SUBJECT: LER REPORTING AND OTHER MISCELLANEOUS CHANGES
(TAC 55724 AND 55930)

Re: Monticello Nuclear Generating Plant

AMENDMENT TO FACILITY OPERATING LICENSE

Amendment No. 46
License No. DPR-22

NSP CORPORATION ORGANIZATION
RELATIONSHIP TO ON-SITE
OPERATING ORGANIZATIONS

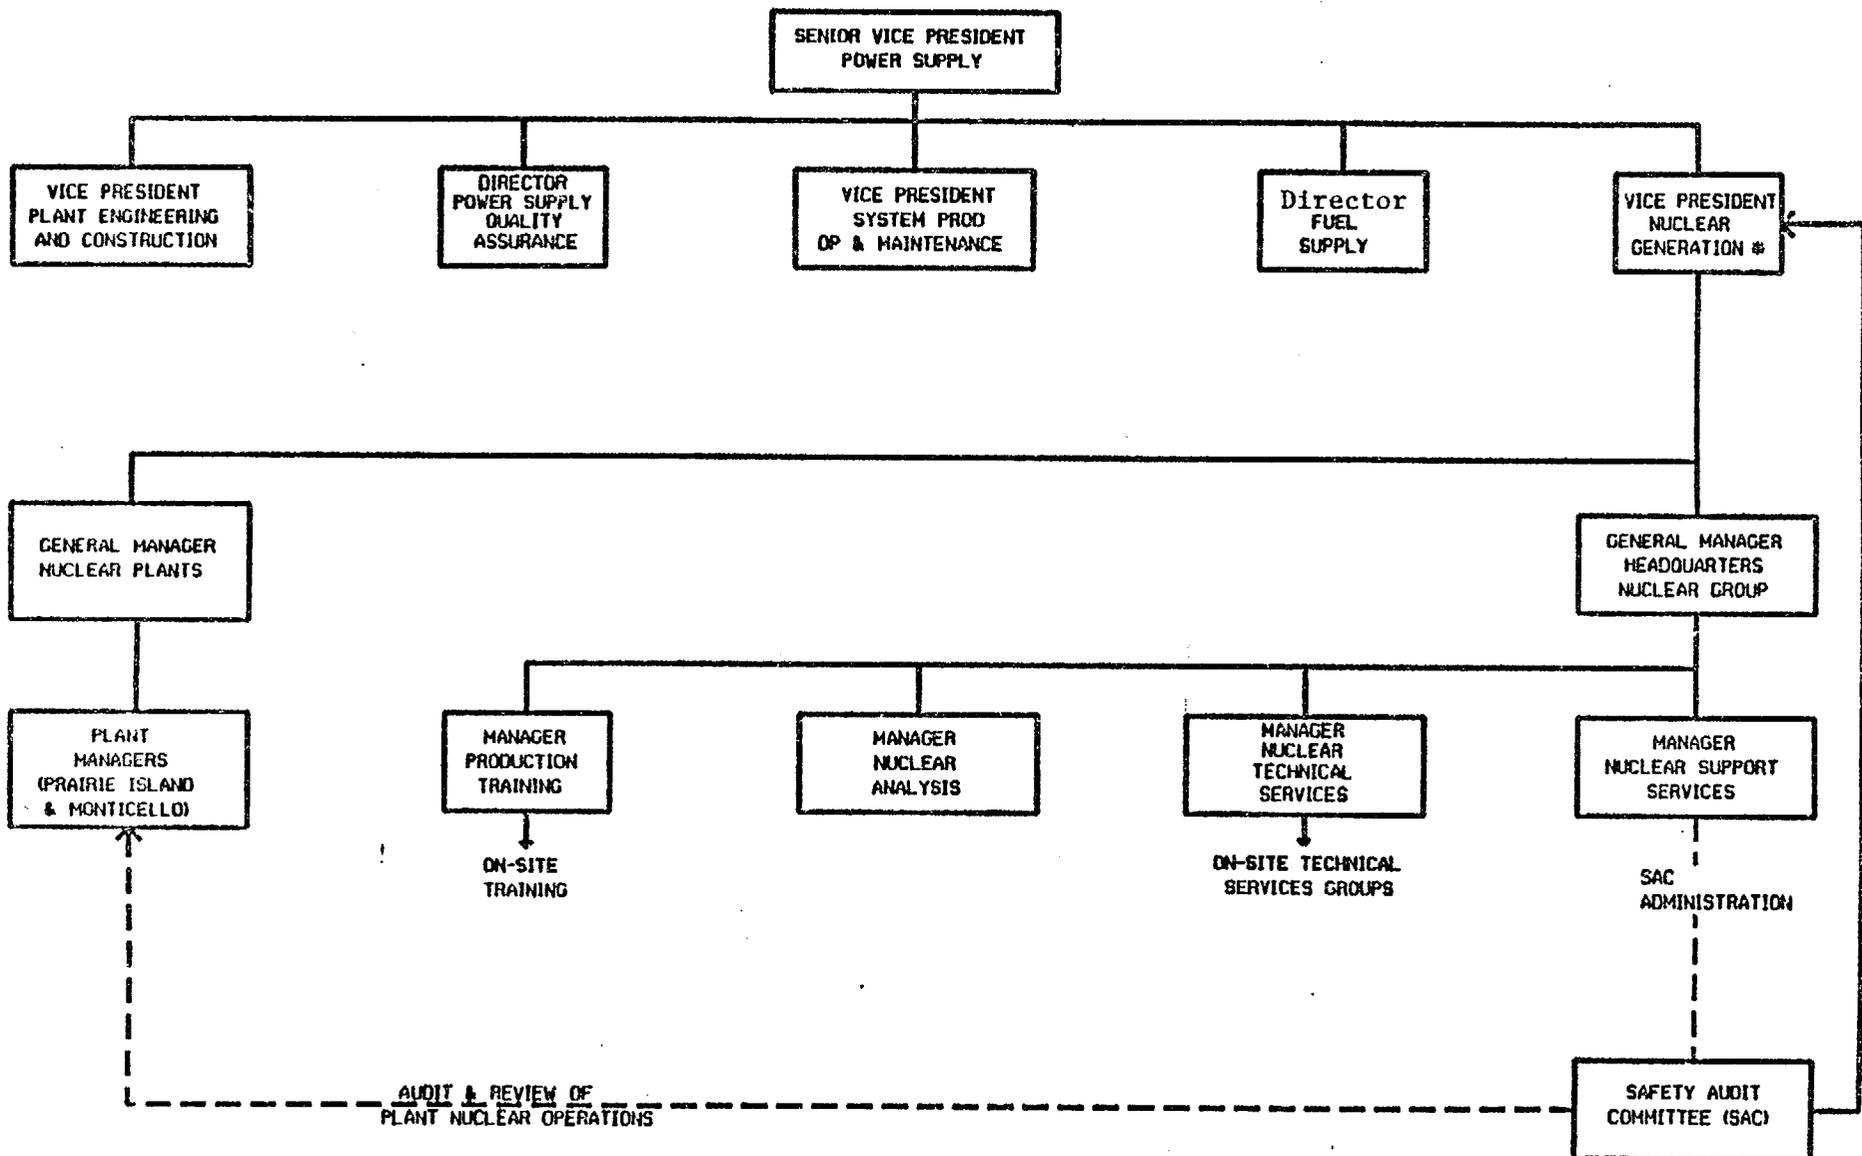
In the above submittal, the licensee also included three organization changes. The titles of Director of Nuclear Generation has been changed to Vice-President, Nuclear Generation, and the General Superintendent, Nuclear Analysis to Manager, Nuclear Analysis. A new position, Assistant Plant Manager, has been added to the organization. These changes required modification to the organization chart, Figure 6.1.1, page 234 and title changes on pages 235, 237, 240, and 242.
